Request for Class II Permissive Change(C2PC)

FCC ID: VG8EC028AYY

This is a C2PC application for which the previous grant was issued on 2023-05-16.

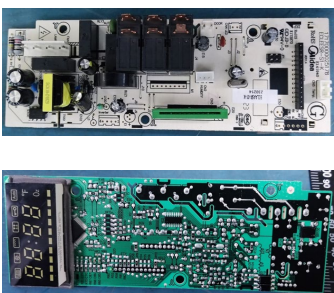
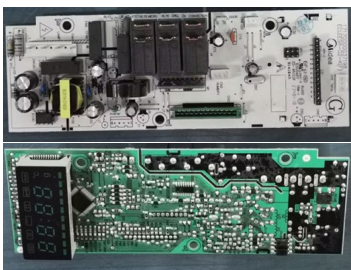
No.:	Original	New	Difference(s)
1			Keypad: Updated front keypad to accommodate child lock function (Child resistant oven door function).
2			Mother board: Modified the peripheral circuit (non-RF circuit) and some individual components and PCB layout. The magnetron and other circuit are exactly same as before.
3	Not Applicable		The new one adds a solenoid valve locking mechanism, the original is not.
